MIL-S-28867(EC)
AMENDMENT 2
14 November 1983
SUPERSEDING
AMENDMENT 1
25 August 1983

MILITARY SPECIFICATION

SWITCH, FREQUENCY STANDARD, SA-2424/W

This amendment forms a part of Military Specification MIL-S-28867(EC), dated 2 October 1981 and is approved for use by the Naval Electronic Systems Command, Department of the Navy, and is available for use by all Departments and Agencies of the Department of Defense.

FIGURE 2. Relay box wiring d

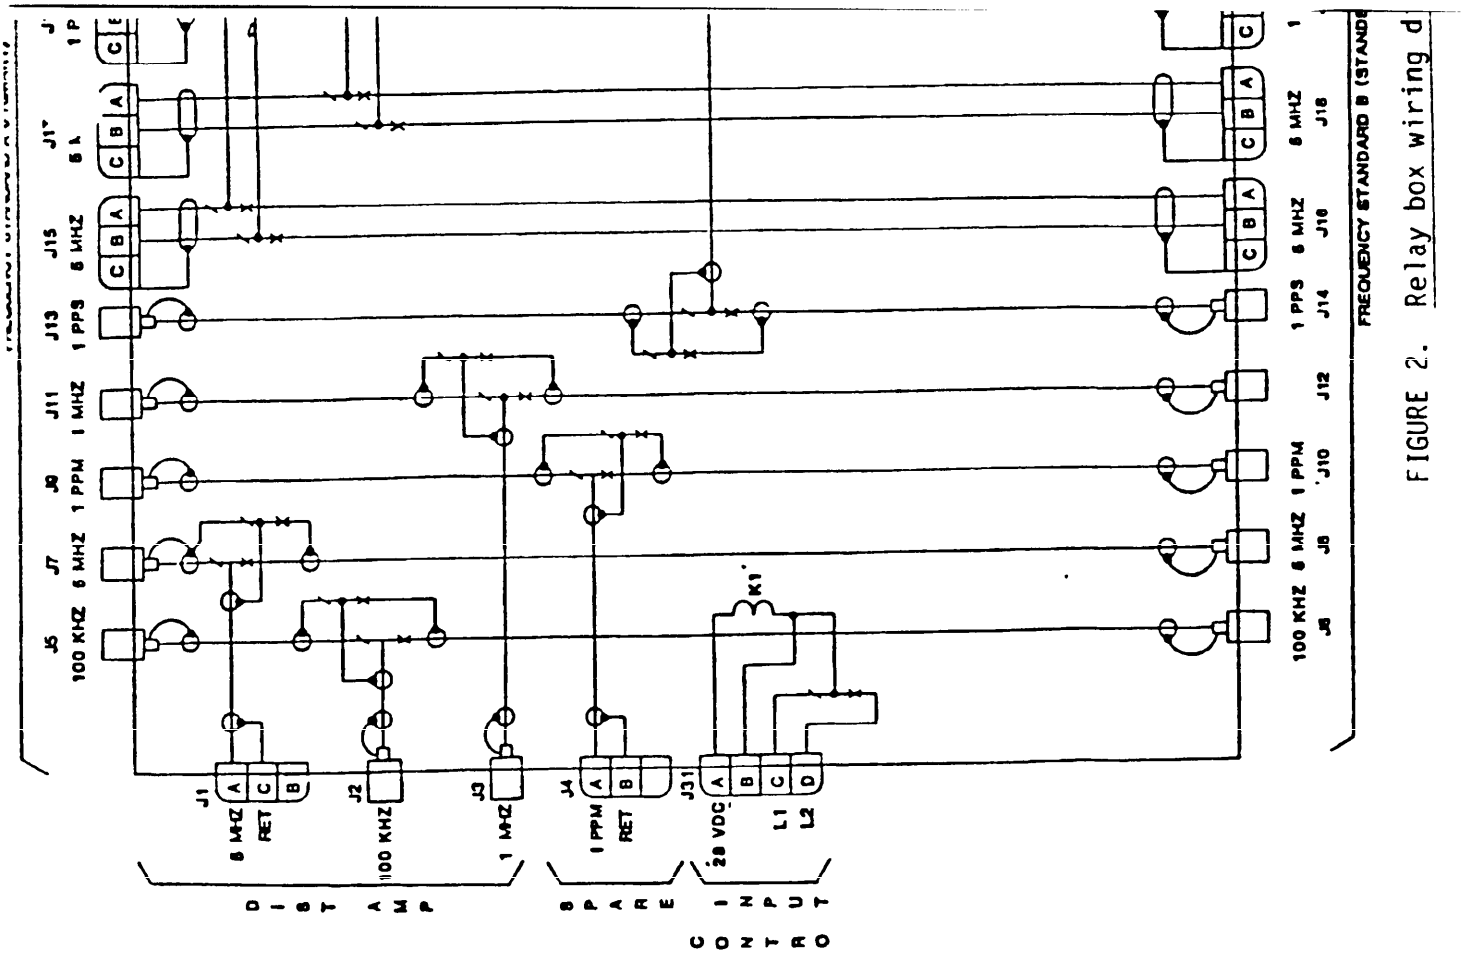
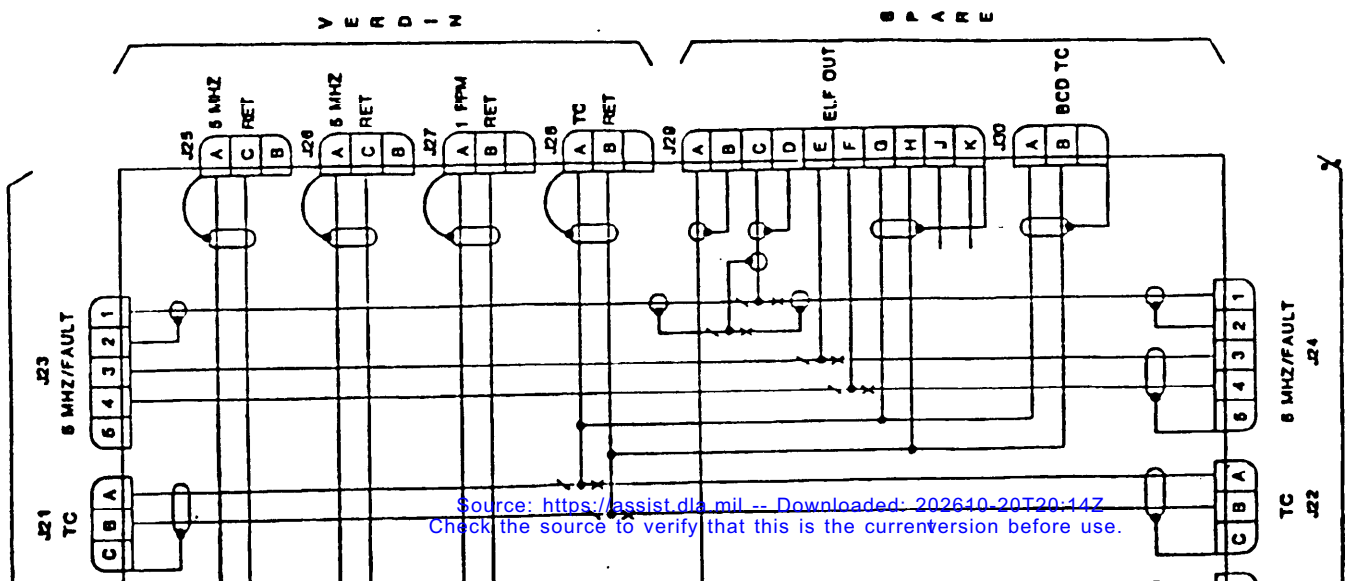
* FIGURE 2: Delete and substitute the attached new FIGURE 2.

FIGURE 3. Transfer switch enclosures.

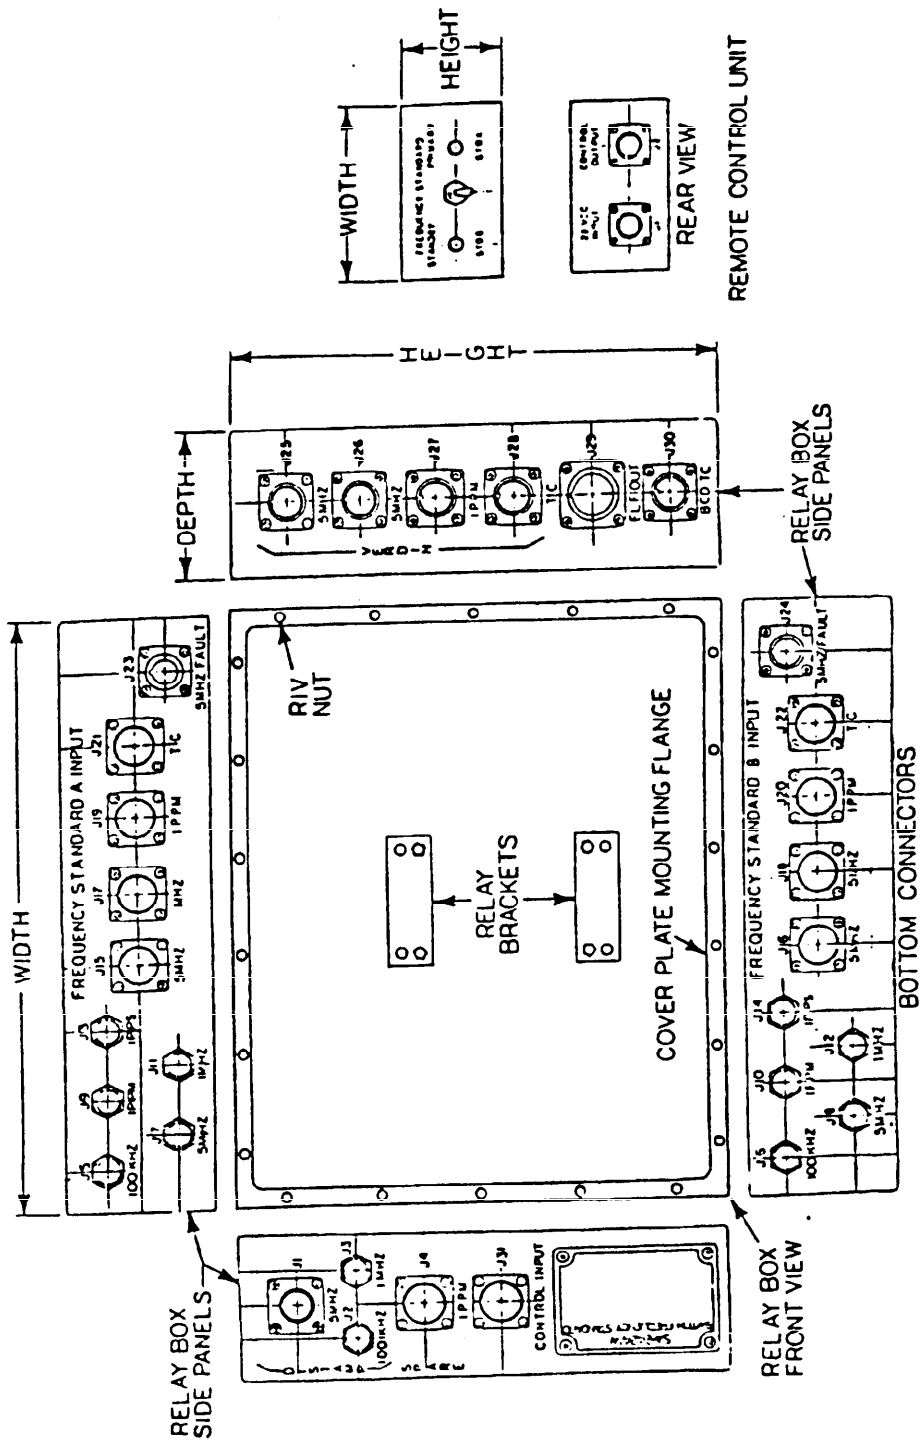
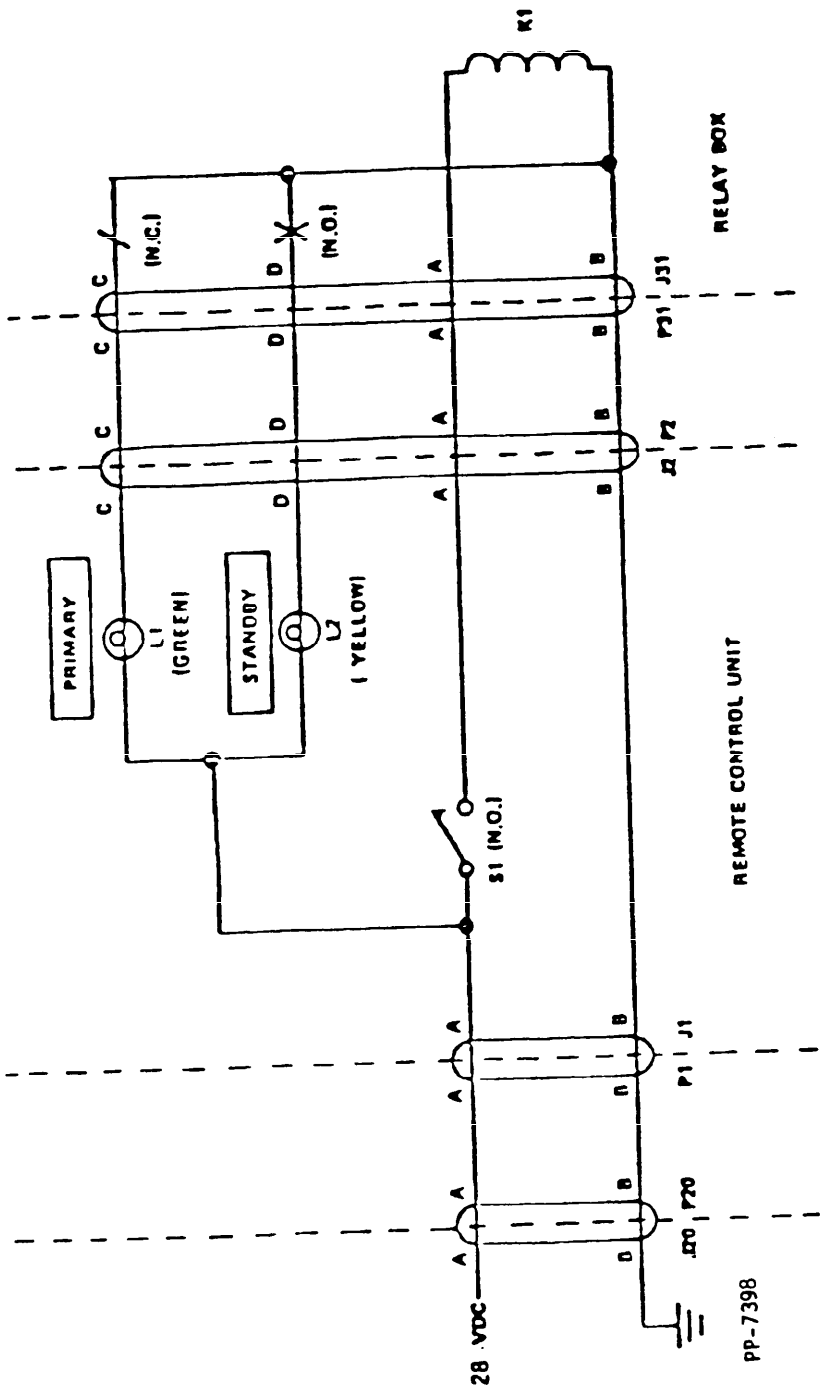
* FIGURE 3: Delete and substitute the attached new FIGURE 3.

FIGURE 5. Remote control unit wiring diagram.

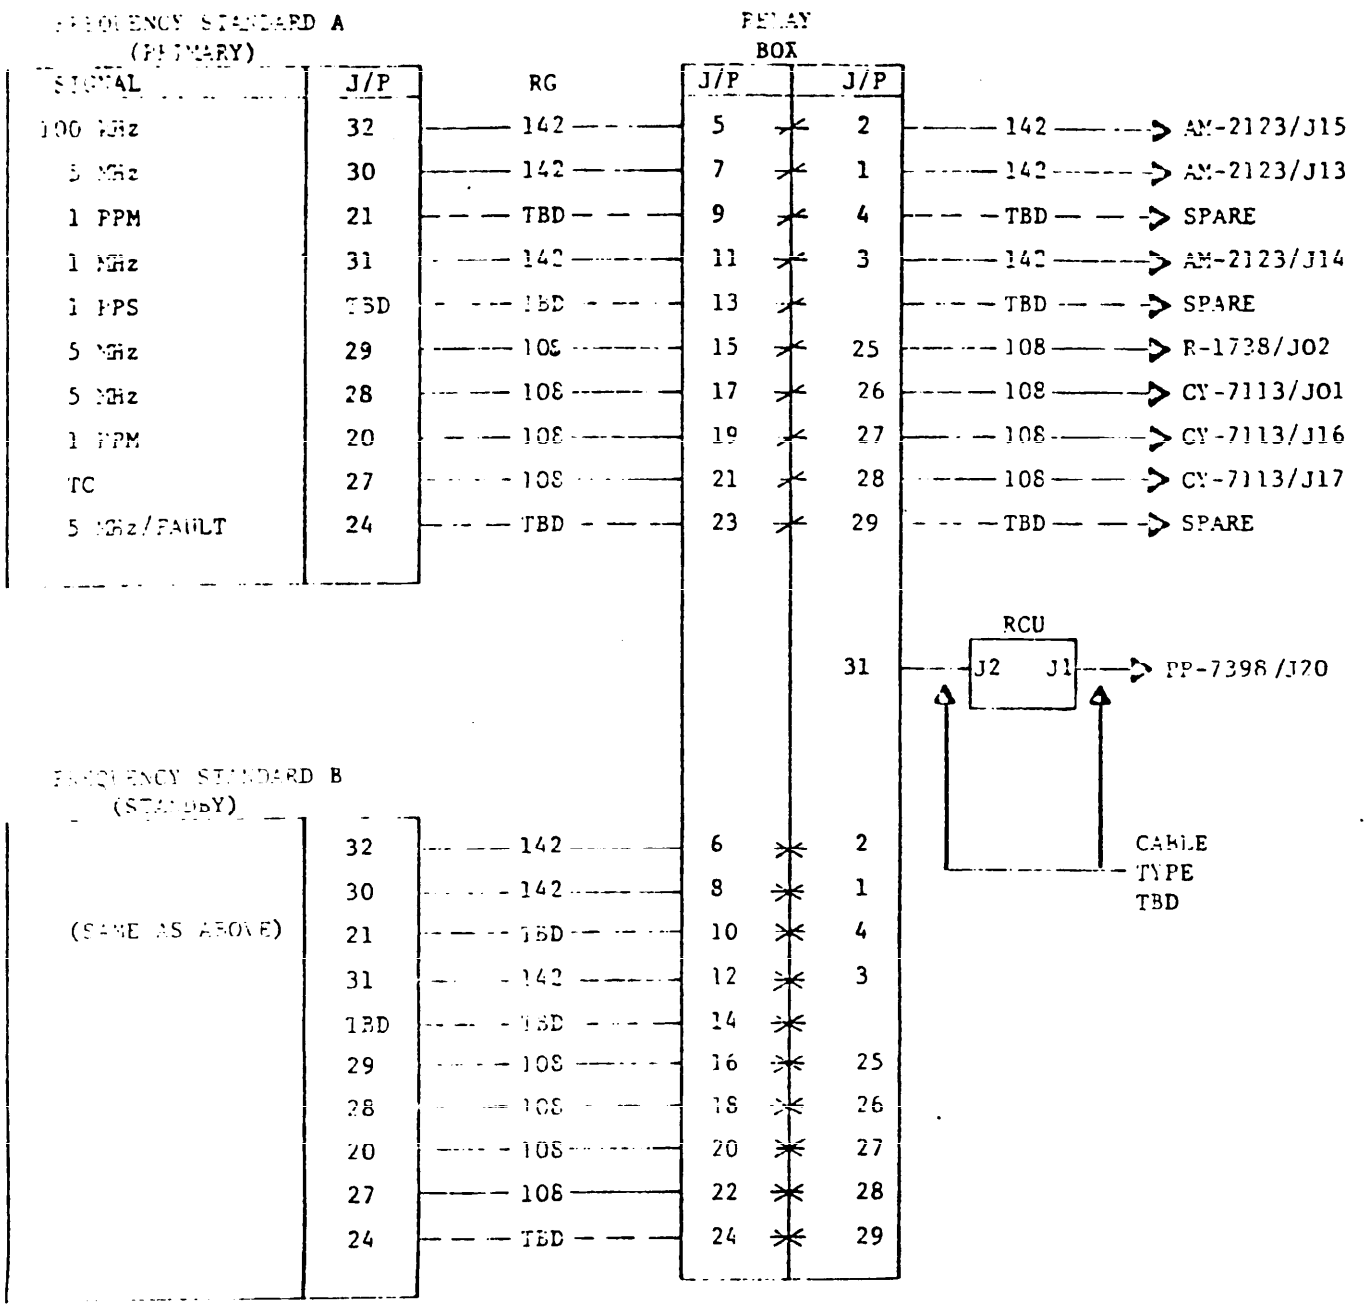
* FIGURE 5: Delete and substitute the attached new FIGURE 5.

FIGURE 6. Transfer switch interconnection wiring diagram (sheet 1).

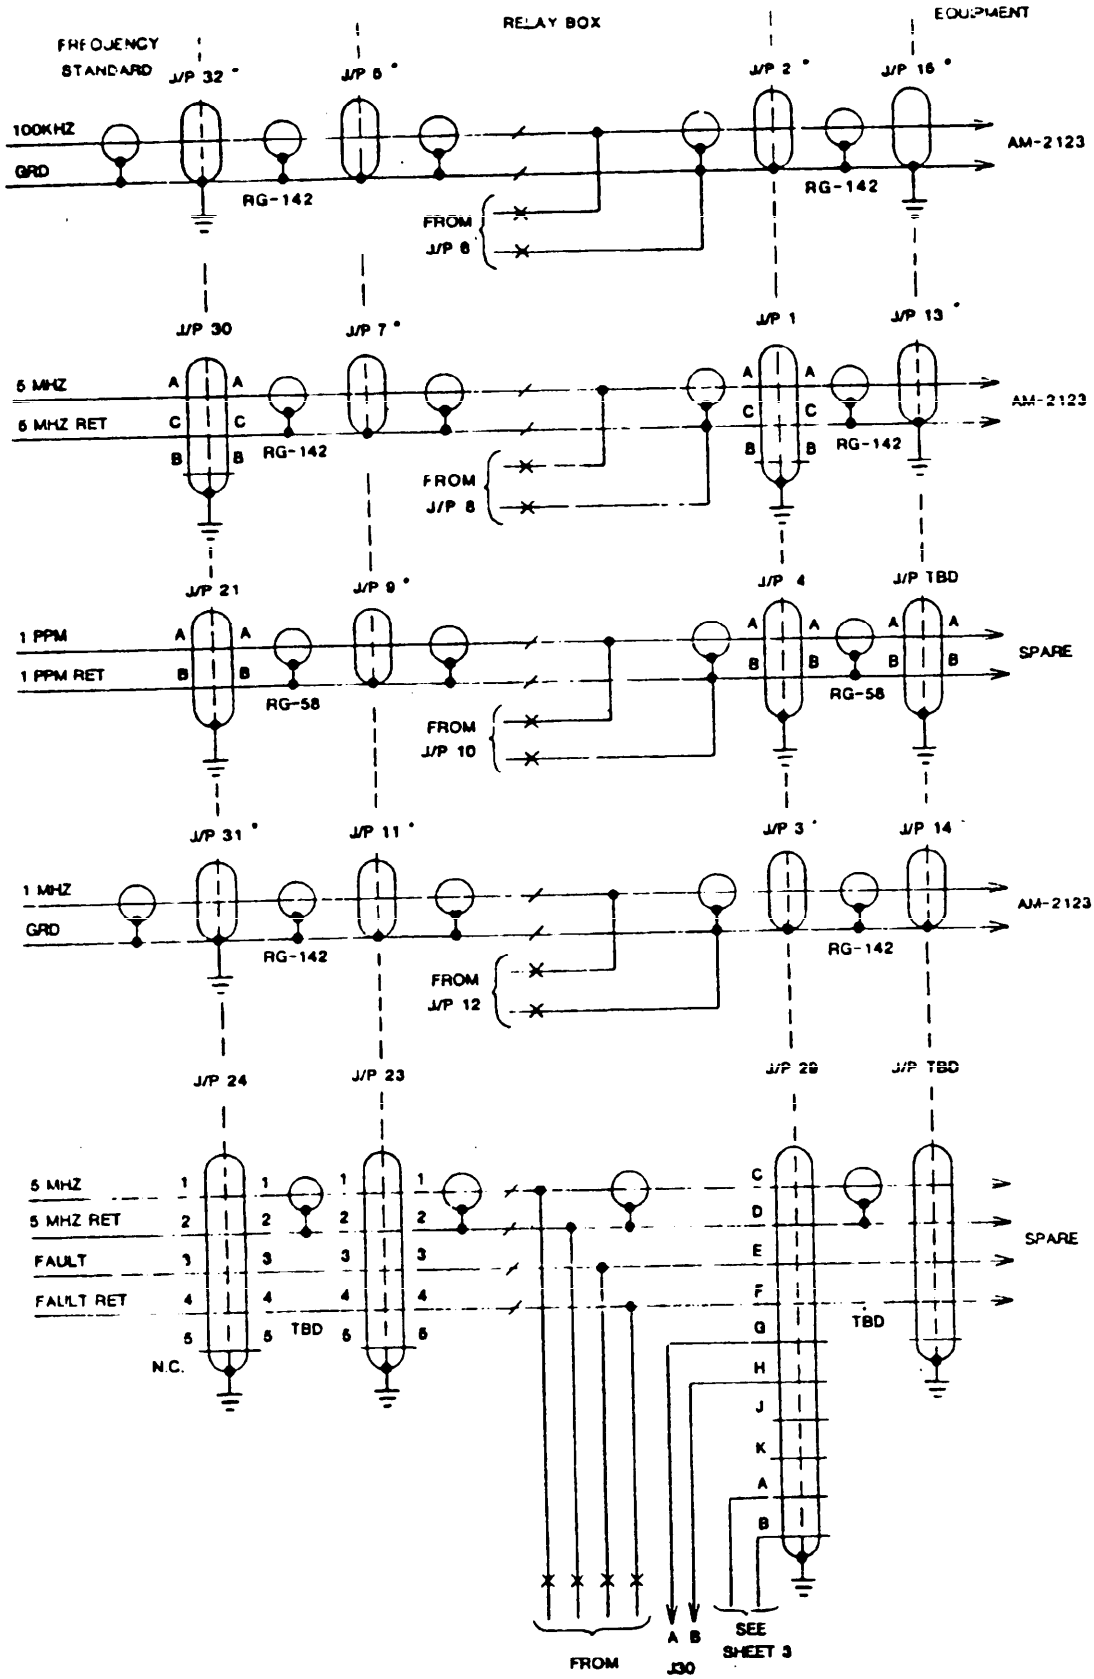
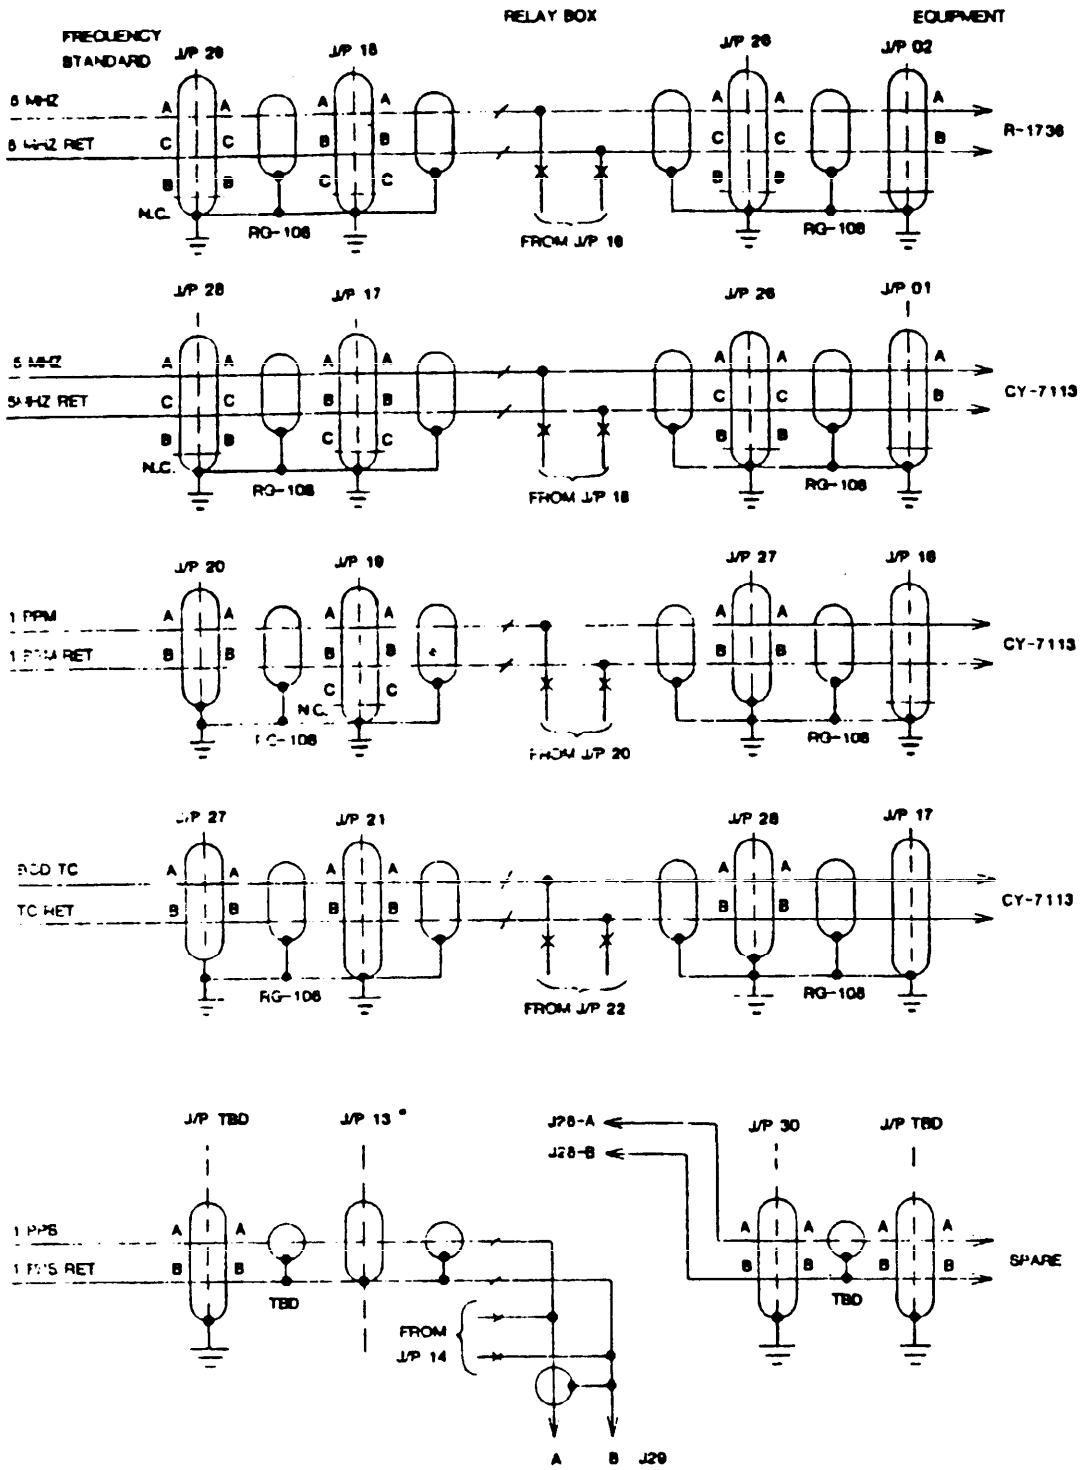
* FIGURE 6: Delete and substitute the attached new FIGURE 6.
